Model: V-C2 RT4000 (SIBERIA)	Date:24-Jun-09	No.: RD350001
------------------------------	----------------	---------------

Subject: Paper Size Sensor		Prepared by: T.Toriumi	
From: 2nd Tech. Support Sec. Service Support Dept.			
Classification:	<input type="checkbox"/> Troubleshooting <input type="checkbox"/> Mechanical <input type="checkbox"/> Paper path <input type="checkbox"/> Other (      )	<input checked="" type="checkbox"/> Part information <input type="checkbox"/> Electrical <input type="checkbox"/> Transmit/receive	<input type="checkbox"/> Action required <input type="checkbox"/> Service manual revision <input type="checkbox"/> Retrofit information

Model: V-C2 RT4000	Date:24-Jul-09	No.: RD350002
--------------------	----------------	---------------

Subject: Parts Registration (RT4000 Relay Unit)		Prepared by: T.Toriumi	
From: 2nd Tech. Support Sec. Service Support Dept.			
Classification:	<input type="checkbox"/> Troubleshooting	<input checked="" type="checkbox"/> Part information	<input type="checkbox"/> Action required
	<input type="checkbox"/> Mechanical	<input type="checkbox"/> Electrical	<input type="checkbox"/> Service manual revision
	<input type="checkbox"/> Paper

## 10. Paper Tray 8 (D350)

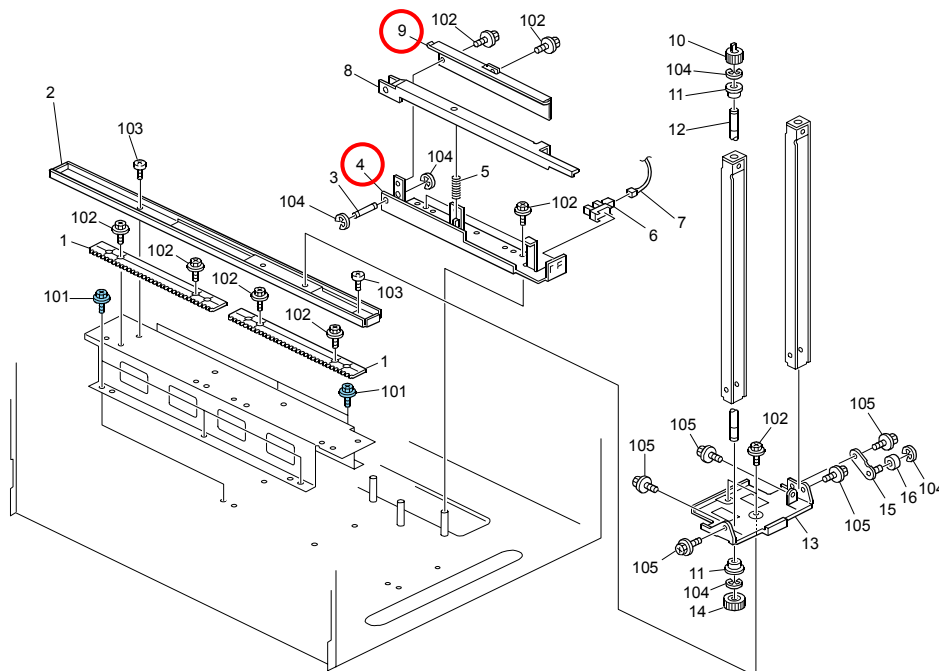
**Change:** The following parts (Index#4 and #9) were changed.

**Reason:** To correct the bug in which the paper size is not displayed on the operation panel correctly.

Old part number	New part number	Description	Q'ty	Int	Page	Index	Note
B8343169	D3553169	PAPER SIZE SENSOR PLATE	1-1	X/O	21	9	-
B8344593	D3553168	PAPER SIZE SENSOR BRACKET – LONG	1-1	X/O	21	4	-
-	04514008N	Tapping Screw:4x8	1-2	-	21	102	-

## SYMPTOM

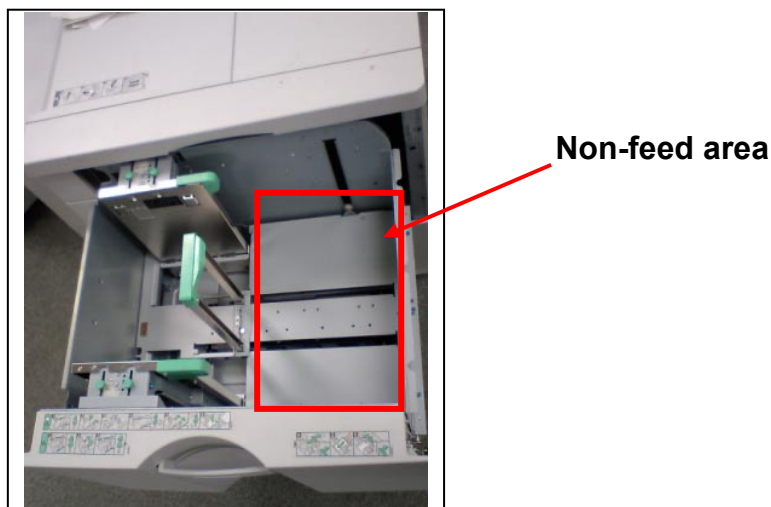
The machine tries to move the tray bottom plate (P/N: D3554620) past the upper limit, creating noise. As a result, the paper tray cannot be opened and the tray bottom plate (P/N: D3554620), bottom plate support (P/N: D3554621), and/or paper feed sensor (P/N: AW020160) breaks.

The customer loads A4/A5/LT-sized paper in the LCT in the “non-feed area” shown in the photograph, instead of in the correct space on the left side of the tray.

- If the bottom plate, bottom plate support, or paper feed sensor is damaged due to the above cause, replace the damaged part(s).
- Remind customers of the **correct way to load paper** in the tray, emphasizing that paper should not be loaded in the “non-feed area” shown in the photo.

## 8.Paper Tray 6 (D350)

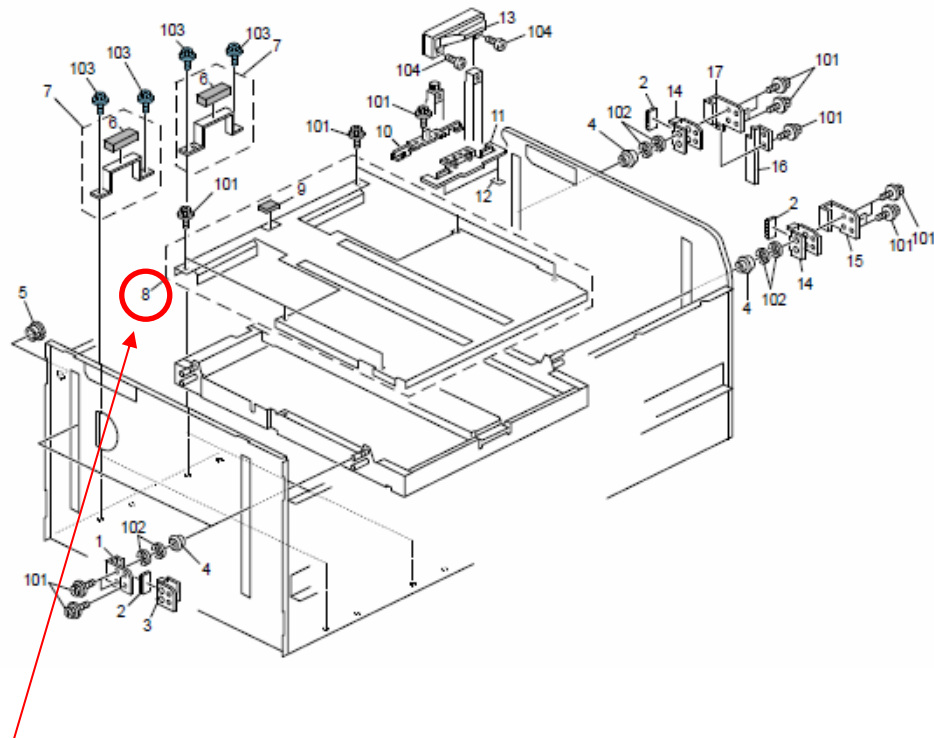
Tray Bottom Plate (P/N: D3554620)

## 4.Paper Tray 2 (D350)

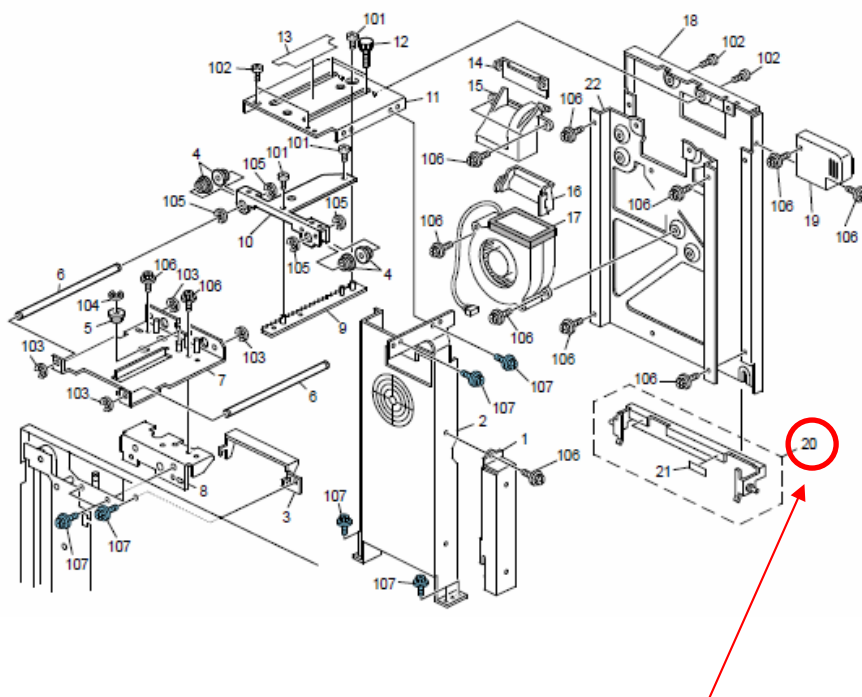
Tray Bottom Plate – Support (P/N: D3554621)

## 5.Paper Tray 3 (D350)

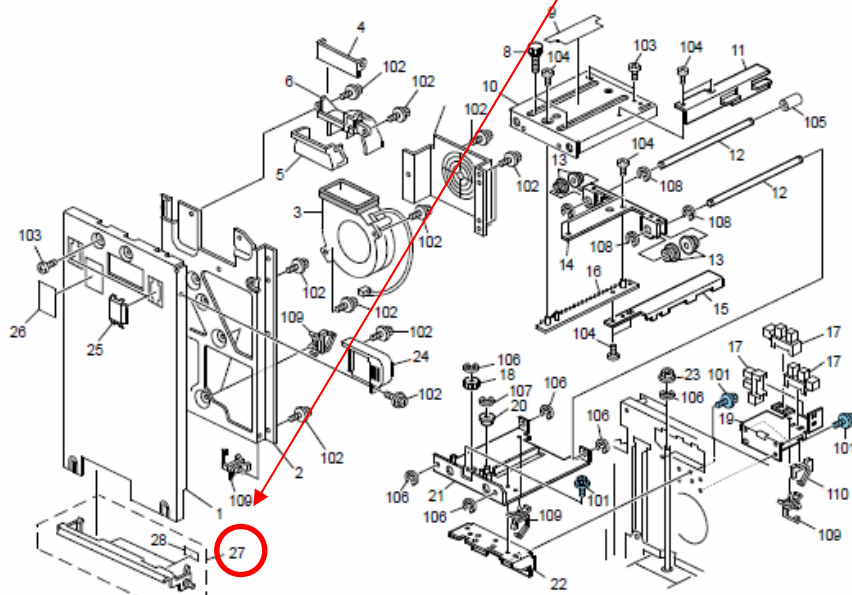
Paper Feed Sensor (P/N: AW020160)

### 4.Paper Tray 2 (D350)

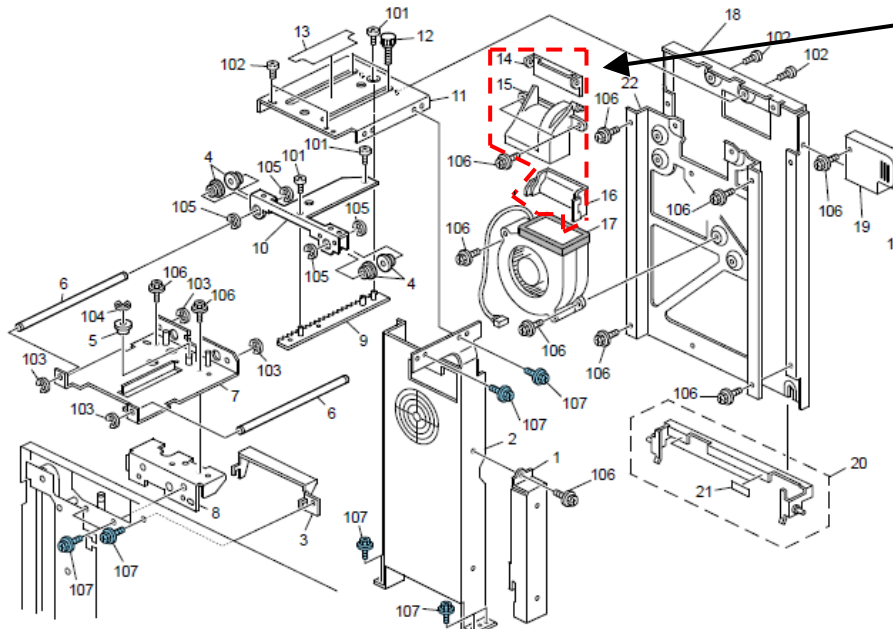
Cover: Duct (D3553363 Index#14), DUCT:UPPER FRONT:BLOWER (D3553361 Index#15) and Duct: Lower: Brower (D3553372 Index#16) can't be replaced independently. If these parts need to be replaced, please install DUCT: UPPER FRONT: BLOWER: ASS'Y (D3553365 Index#23).

DUCT: UPPER FRONT:  
BLOWER: ASS'Y  
(D3553365 Index#23)

### 5.Paper Tray 3 (D350)

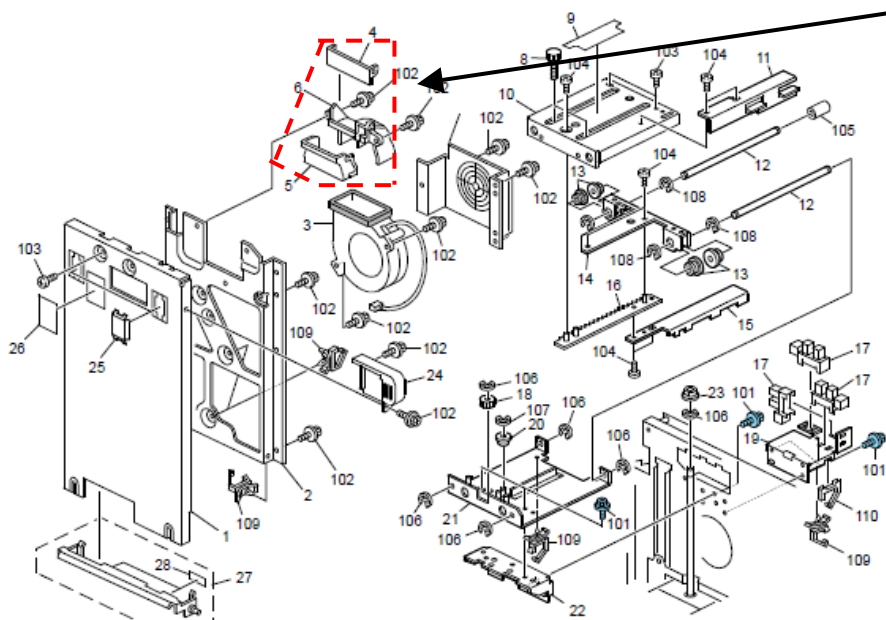
Cover: Duct (D3553363 Index#4), DUCT:UPPER REAR:BLOWER (D3553361 Index#6) and Duct: Lower: Brower (D3553372 Index#5) can't be replaced independently. If these parts need to be replaced, please install DUCT: UPPER REAR: BLOWER: ASS'Y (D3553375 Index#29).

DUCT: UPPER REAR:  
BLOWER: ASS'Y  
(D3553375 Index#29)

## 4.Paper Tray 2 (D350)

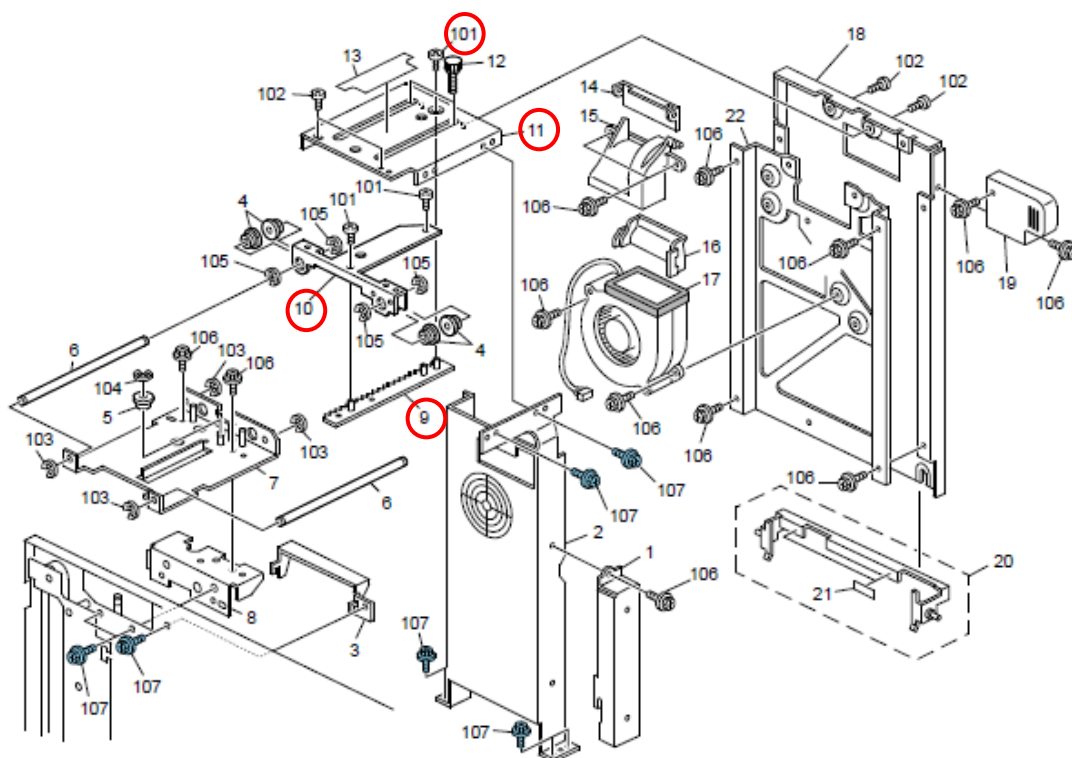
This RTB has been issued to announce that the tray part for the LCIT has been changed

Old part number	New part number	Description	Q'ty	Int	Page	Index	Note
04533006N	-	TAPPING SCREW - M3X6	1-0	-	9	101	X/O as a set
D3503339	D3503345	RACK:UPPER	1	X/X	9	9	
B8343332	B8343341	GUIDE:UPPER FRONT	1	X/X	9	10	
B8343357	B8343355	GUIDE:LM-6:UPPER FRONT:PEEN	1	X/X	9	11

### 3. Paper Tray 1 (D350)

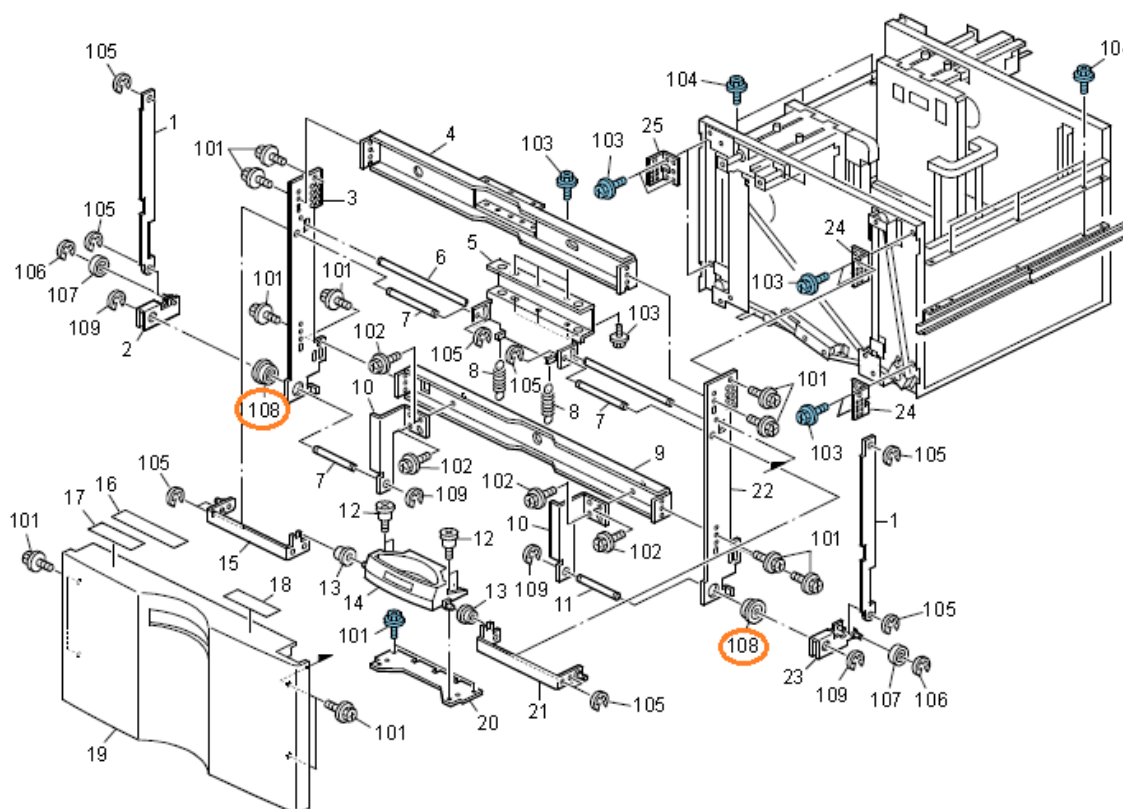
**Change/Reason:** The part number in the Parts Catalog was incorrect.

Incorrect part number	Correct part number	Description	Q'ty	Int	Page	Index	Note
07413808	07423808	Ball Bearing - 8x16x5MM	2	-	7	108	-

## 121.Paper Tray 1 (D095)

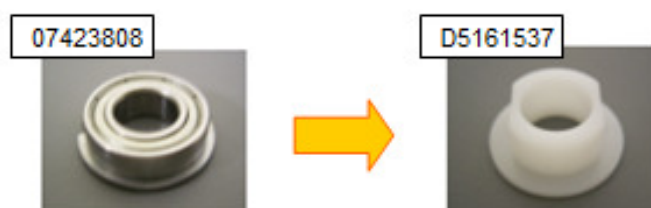
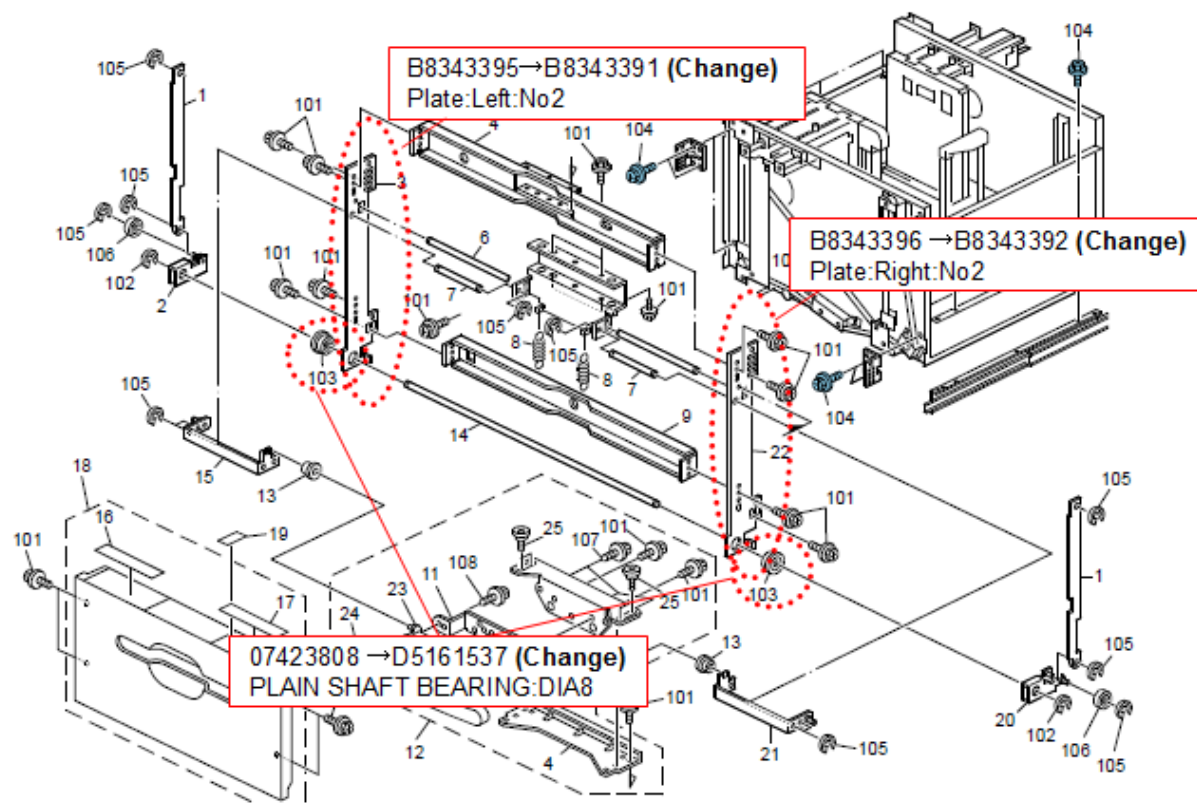
**Change:** Bearing and the shape of the accompanying plates

**Reason:** To share common parts with the LCIT RT5060 (D516)

1, The bearing was changed as shown in the photo below.

2, The size of the holes on the plates were reduced to correspond with the modified bearings.

Old Part Number	New Part Number	Description	Q'ty	Int	Page	Index	Note
07423808	D5161537	Plain Shaft Bdaring:DIA8	2	X/O	266	103	
B8343395	B8343391	Plate:Left:No.2	1	X/O	266	3	
B8343396	B8343392	Plate:Right:No.2	1	X/O	266	22

- **Make sure all 3 parts shown in the above table are replaced as a set.**
- **The modification described in this bulletin also applies to Aegis-C1 (D016), Aries-C1 Lt (D097), LCT RT4000 (D350), LCT RT5020 (D355), and LCT RT5050 (D532).**

### 3.Paper Tray 1 (D350)

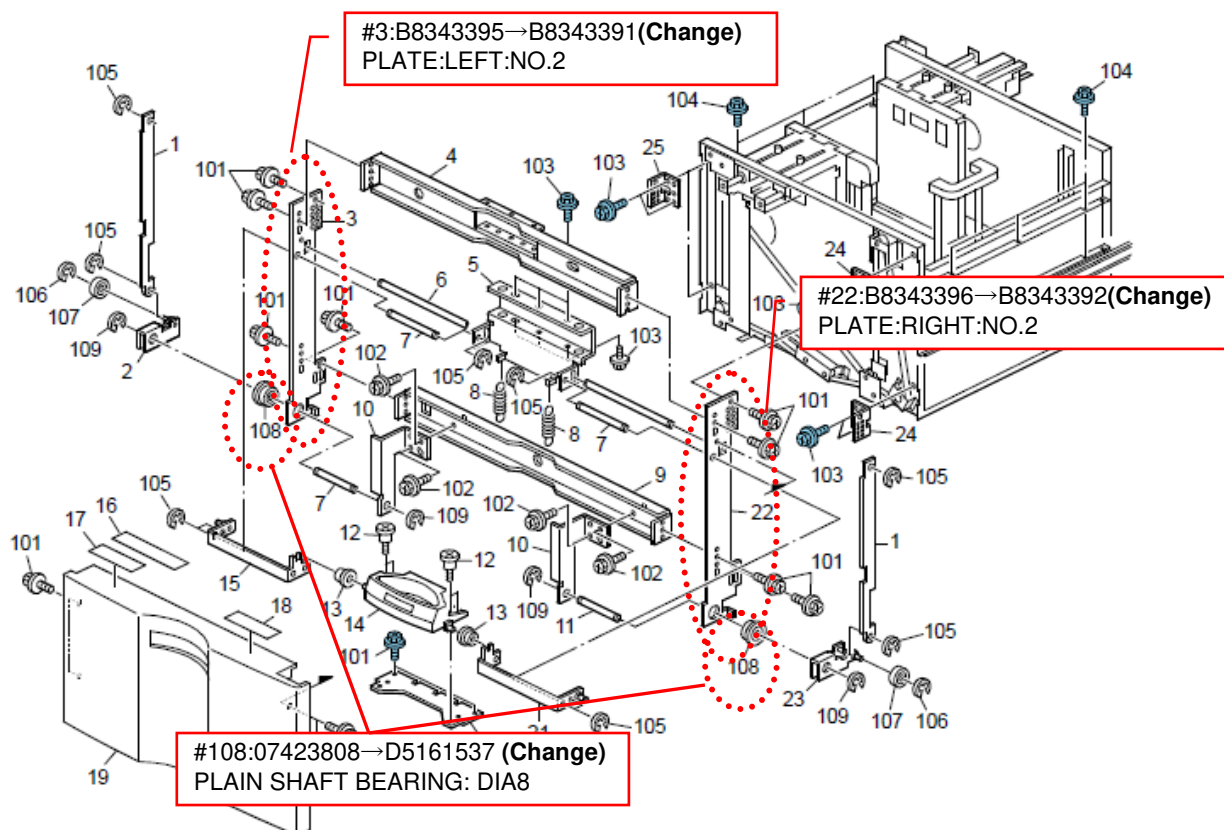
**Change:** Bearing and the shape of the accompanying plates

**Reason:** Vendor change

Old Part Number	New Part Number	Description	Q'ty	Int	Page	Index	Note
07423808	D5161537	PLAIN SHAFT BEARING:DIA8	2	X/X	7	108	X/O as a set
B8343395	B8343391	PLATE:LEFT:NO.2	1	X/X	7	3	
B8343396	B8343392	PLATE:RIGHT:NO.2	1	X/X	7	22

- Make sure all 3 parts in the above table are replaced as a set.

#### 4.Paper Tray 2 (D350)

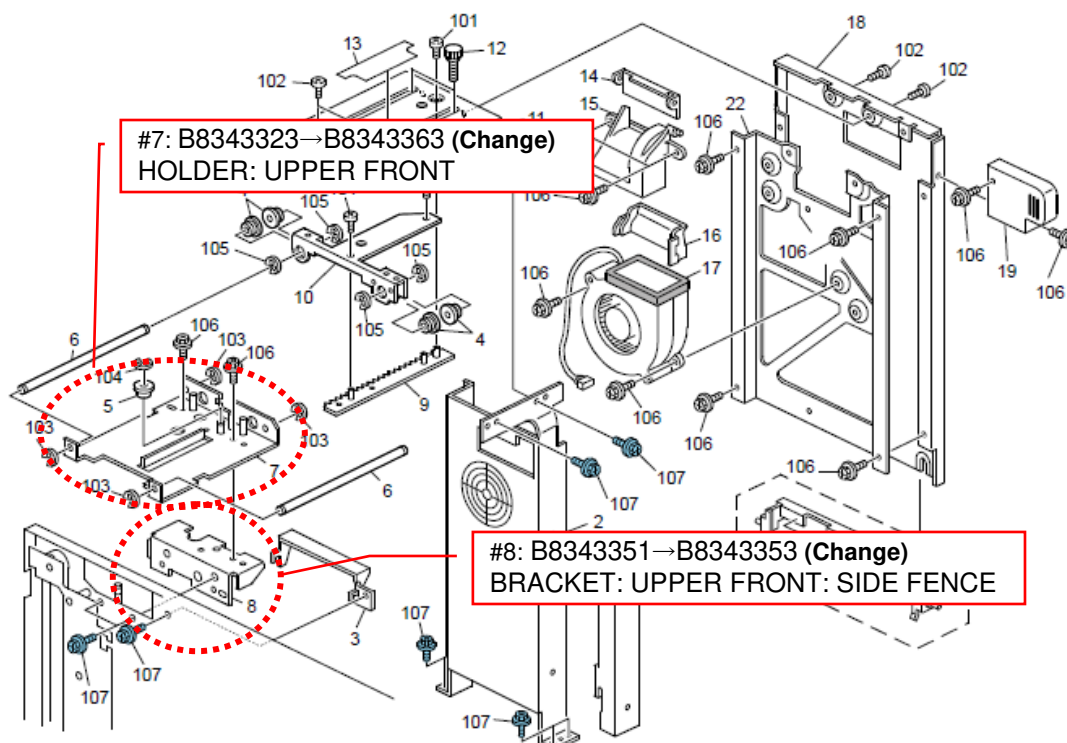
**Change:** Holder and Side fence bracket

**Reason:** To allow usage of common parts for different products

Old Part Number	New Part Number	Description	Q'ty	Int	Page	Index	Note
B8343323	B8343363	HOLDER:UPPER FRONT	1	X/X	9	7	X/O as a set
B8343329	B8343364	HOLDER:UPPER REAR	1	X/X	11	21	
B8343351	B8343353	BRACKET:UPPER FRONT:SIDE FENCE	1	X/X	9	8	
B8343352	B8343354	BRACKET:UPPER REAR:SIDE FENCE	1	X/X	11	22

- When replacing the above parts, replace all 4 parts as a set.

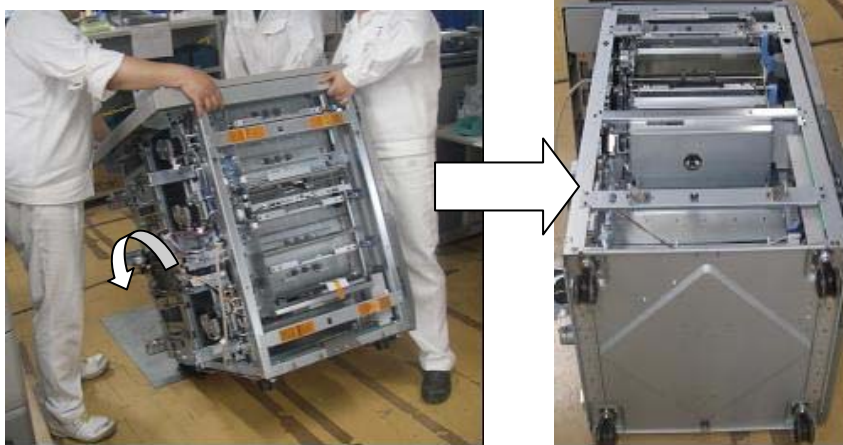
Broken caster on the following LCITs:

One lot of casters was manufactured with an incorrect molding process, resulting in lower durability.

Replace the caster (p/n: AH012050) when a unit with a broken caster is found.  
See the following page for the replacement procedure.

3. Replace the broken caster with a new one. (Screw x4)
